## **ZEIGLER BOULEVARD SHOPPING CENTER SUBDIVISION, RESUBDIVISION OF LOTS 2 AND 3**

APPLICATION NUMBER 15 DATE August 7, 2008  
 Zeigler Boulevard Shopping Center Subdivision,  
 APPLICANT Resubdivision of Lots 2 and 3  
 REQUEST Subdivision

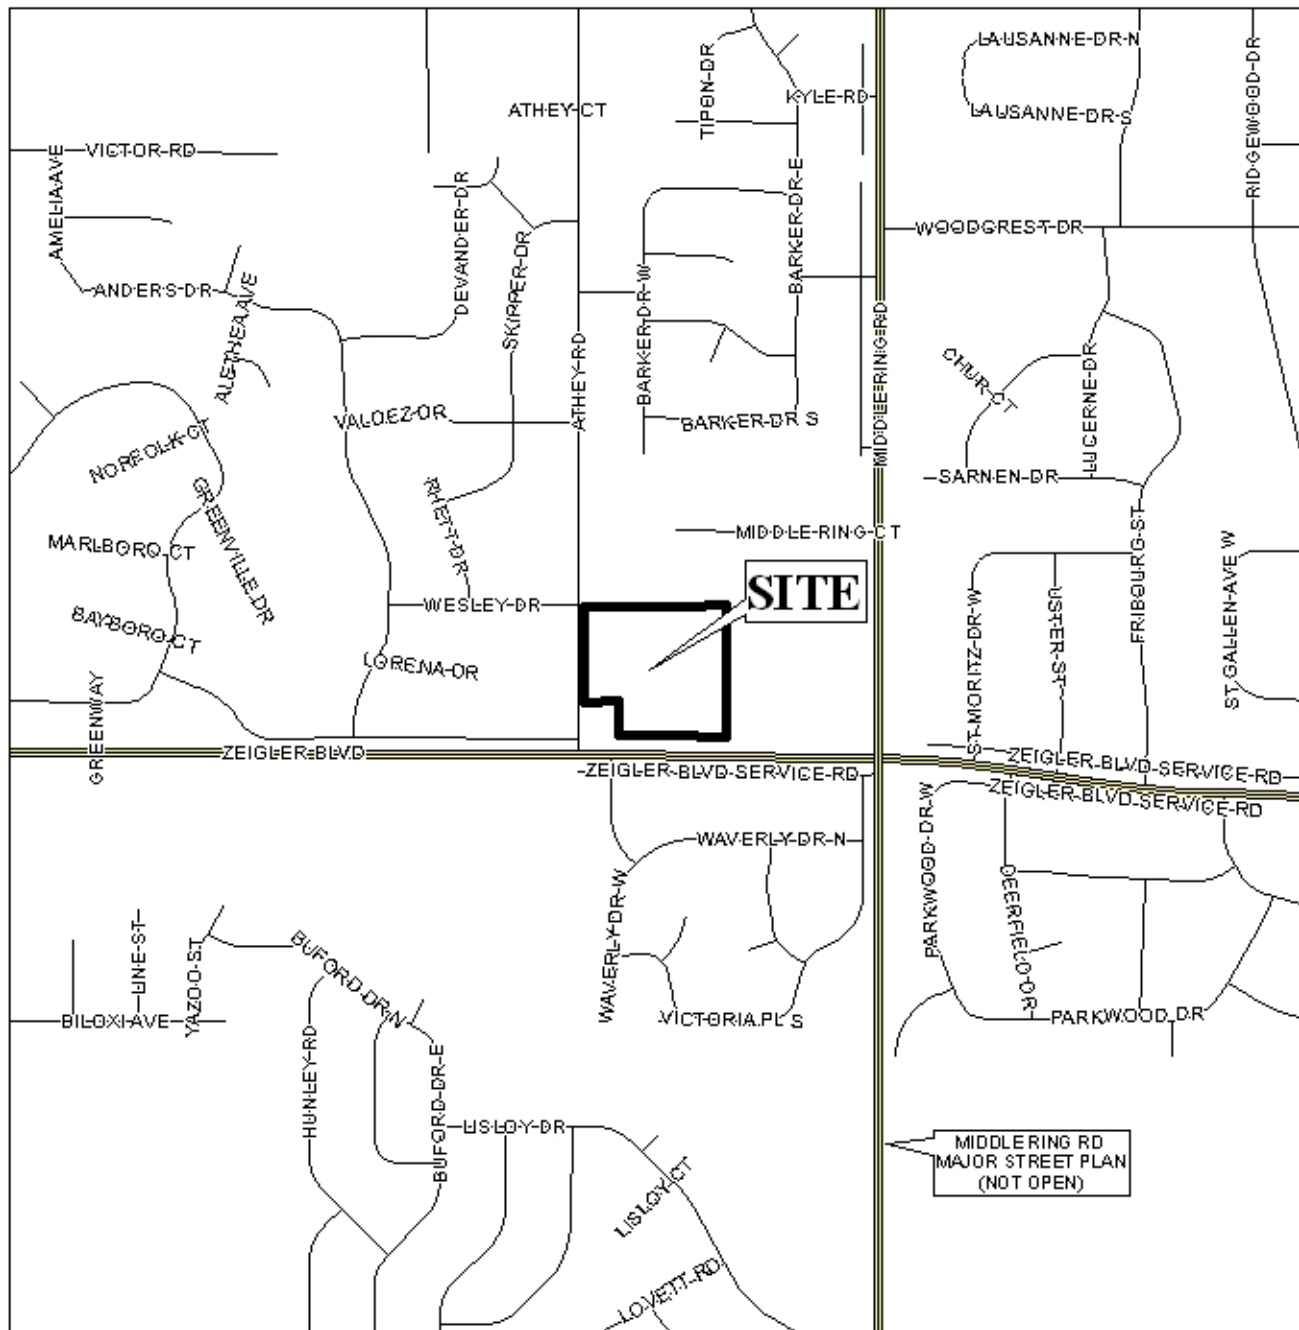
Aerial photographs from 2006 show a building and paved parking area on proposed lot 2. A holdover is recommended to allow the applicant to amend the plat to show any existing structures on the site that will be retained, and paved area and the setback between any structures and the proposed property lines or to place a note on the plat that the structure(s) are to be demolished.

Proposed Lot 1 will have approximately 264' of frontage along Zeigler Boulevard. Proposed Lot 2 would have approximately 226' onto Zeigler Boulevard and approximately 424' along Athey Road. As a means of access management, a note should be placed on the final plat stating that the proposed Lot 1 is limited to one curb cut onto Zeigler Boulevard, while proposed Lot 2 is

limited to one curb cut onto Zeigler Boulevard and limited to the existing three curb cuts onto Athey Road with the size, location, and design to be approved by Traffic Engineering and conform to AASHTO standards.

In addition to showing any current structure on the property, the plat should also be revised to show a 25' minimum building setback line from all street frontages.

Based on the preceding, this application is recommended for a holdover until the September 4th meeting, with revisions due by August 15th, to allow the applicant to submit the following:

- 1) Submittal of a revised plat to show all structures and paved areas with all the proper dimensions and setbacks depicted;
- 2) placement of a note on the final plat stating that any lots which are developed commercially and adjoin residentially developed property must provide a buffer, in compliance with Section V.A.7. of the Subdivision Regulations; and
- 3) Revision of the plat to show a 25' minimum building setback line from all street frontages.
